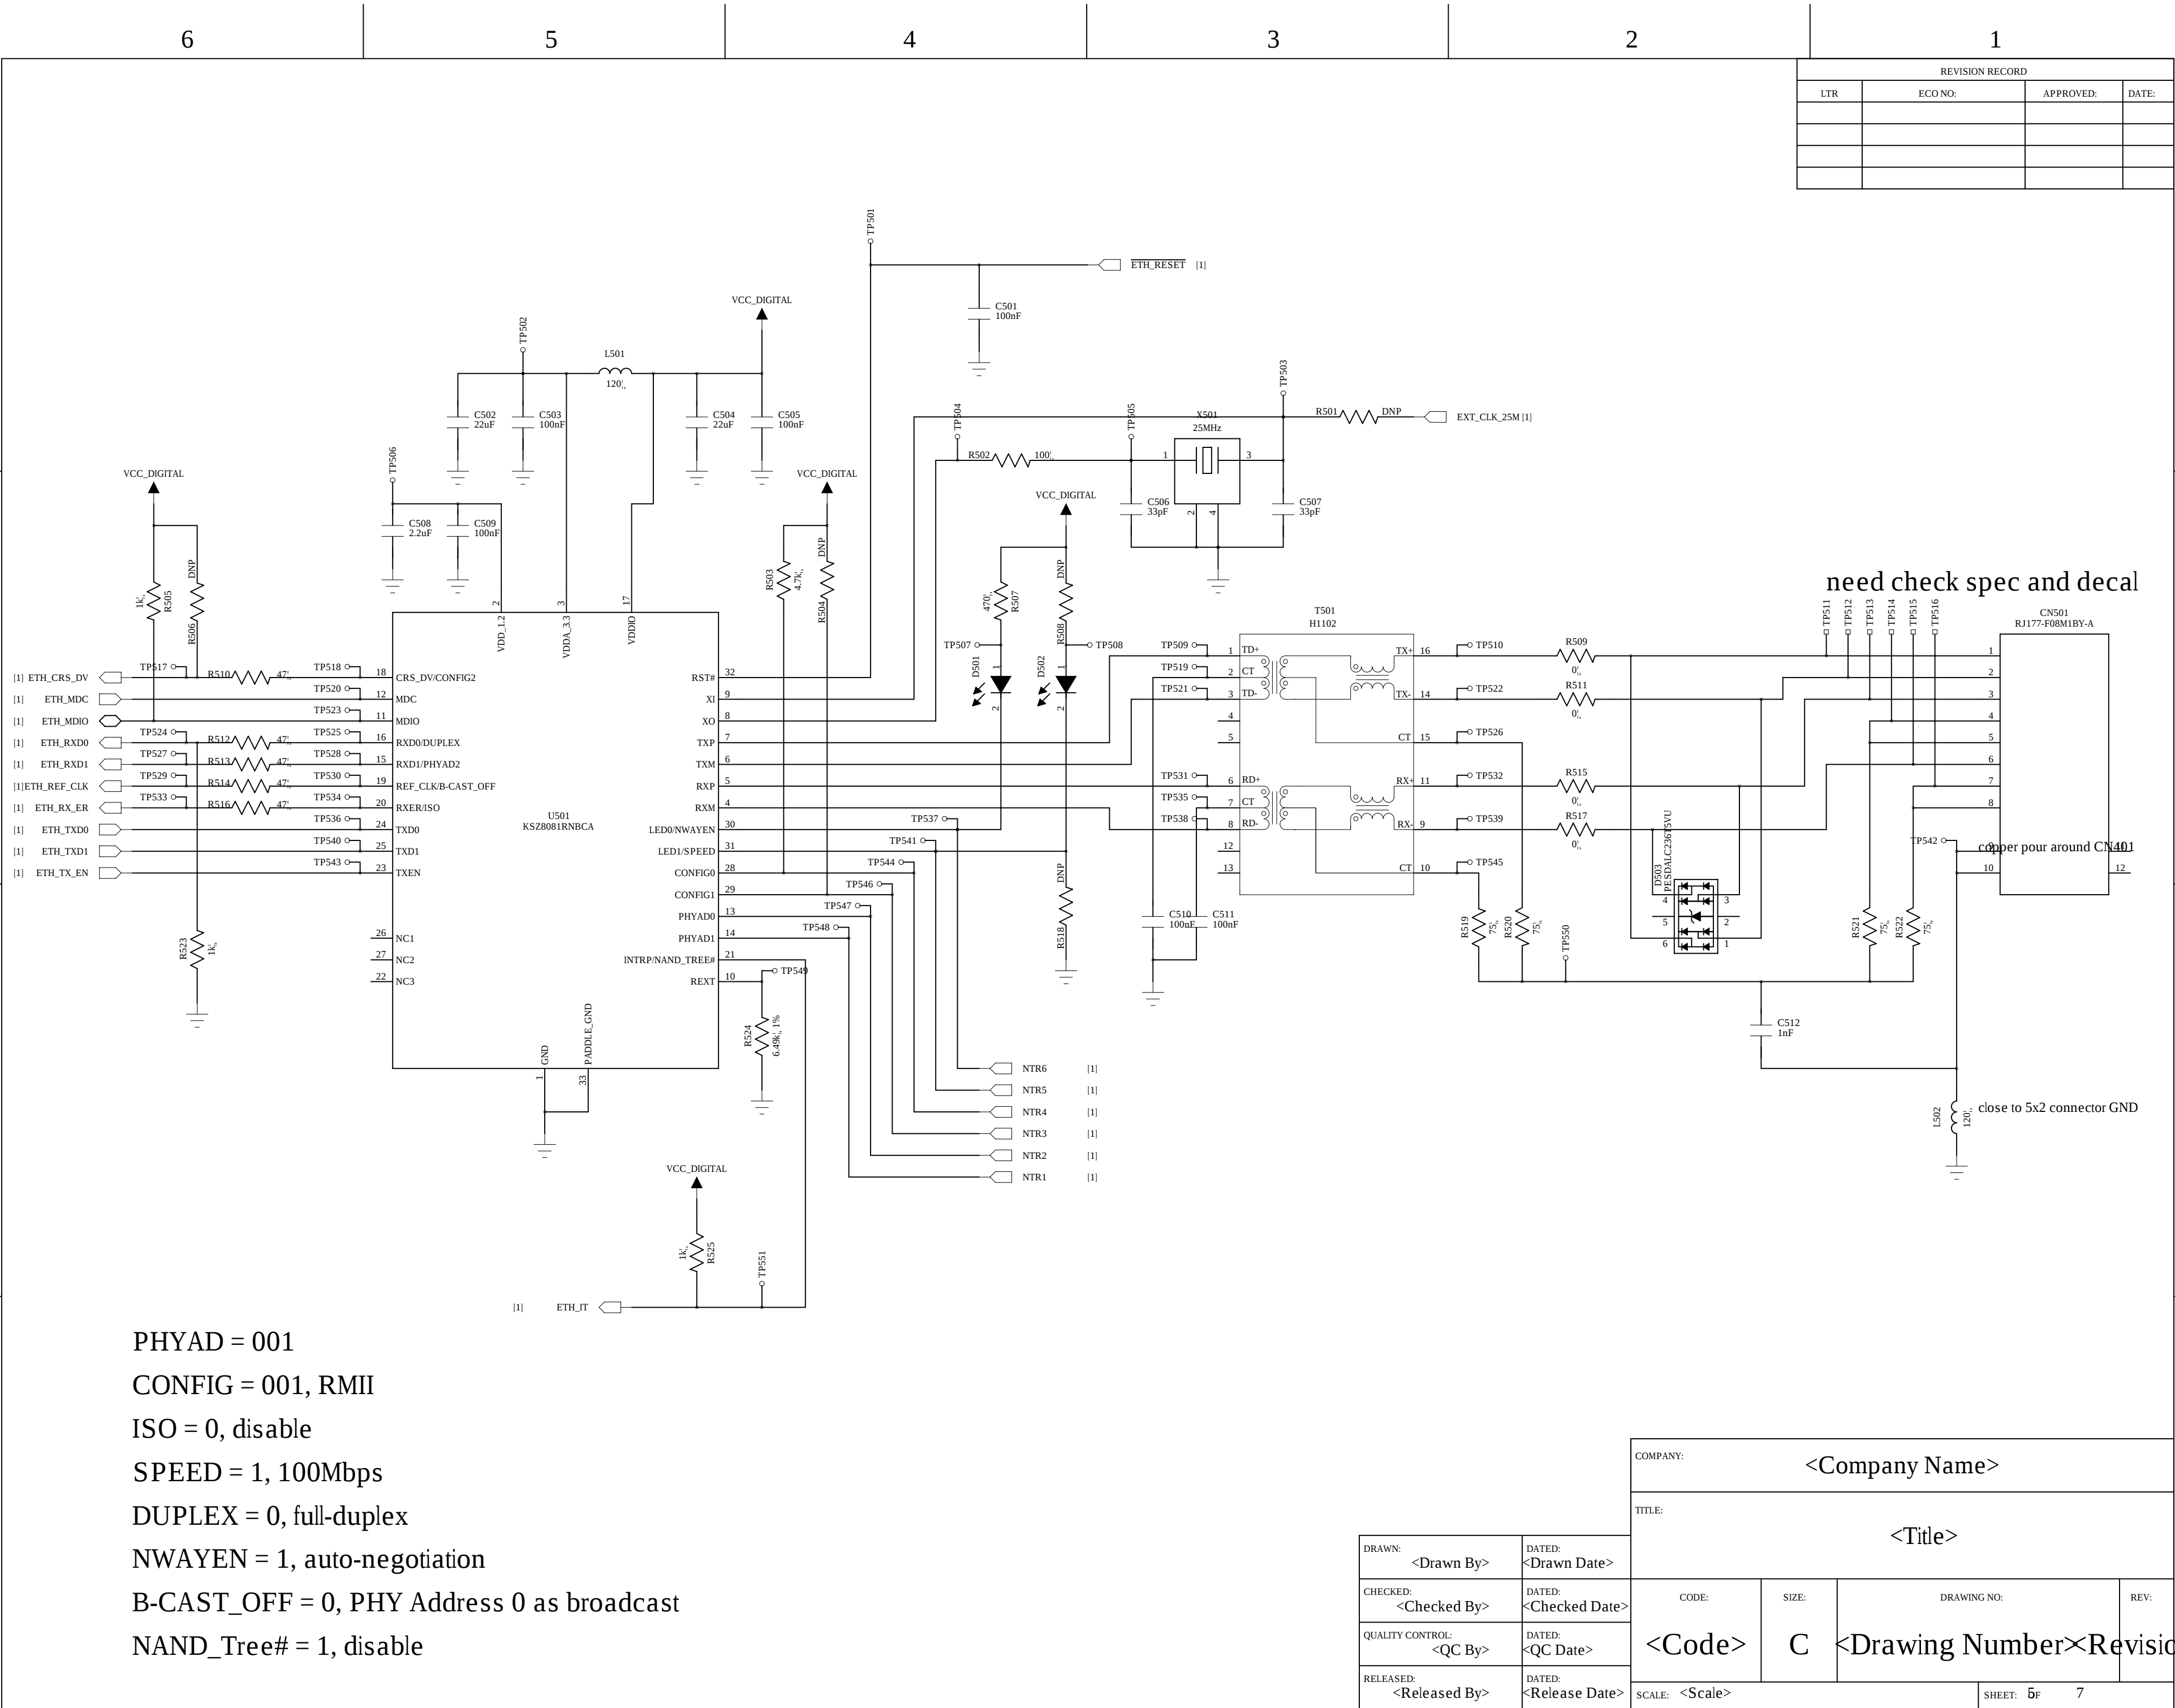
need check spec and decal

copper pour around CN501

close to 5x2 connector GND

COMPANY: <Company Name>			
TITLE: <Title>			
CODE:	SIZE: C	DRAWING NO:	REV:
<Code>		<Drawing Number>	<Revision>
SCALE: <Scale>			SHEET: 6F 7

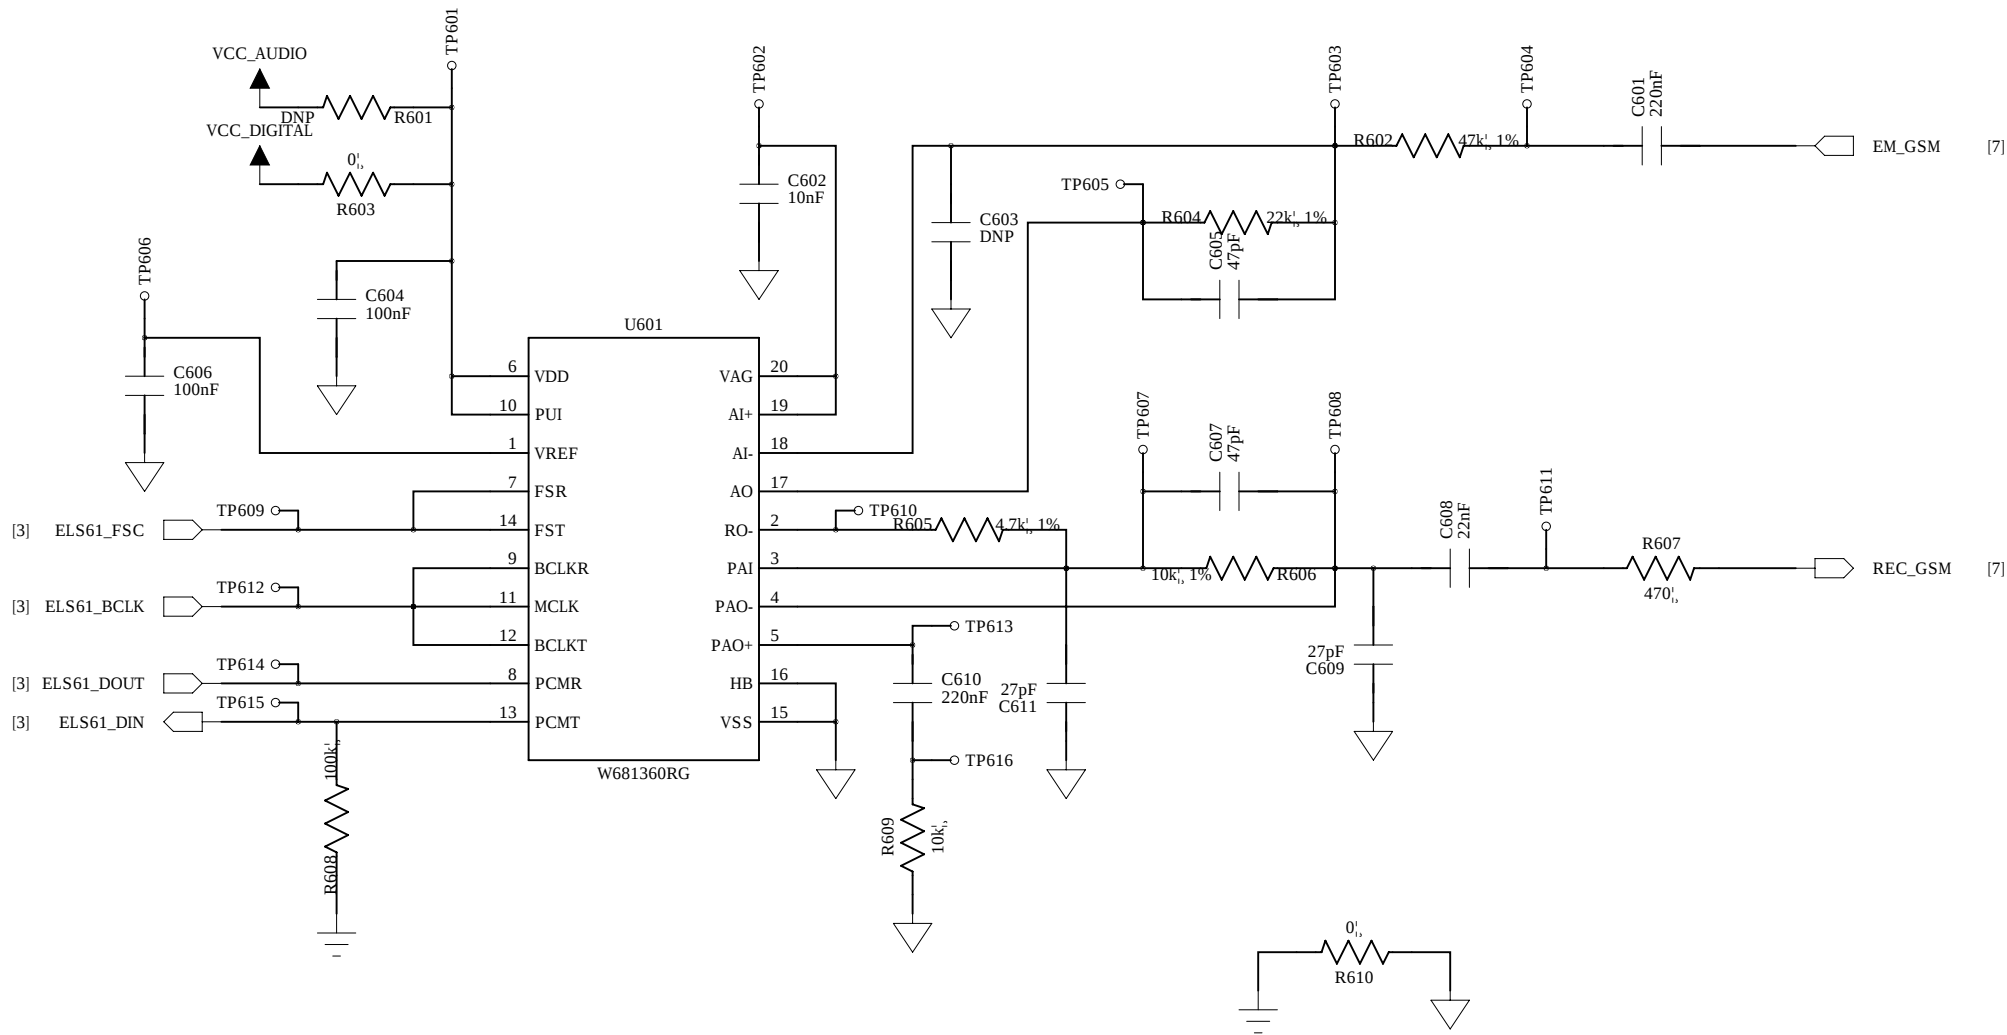
AGND PGND not connected on reference
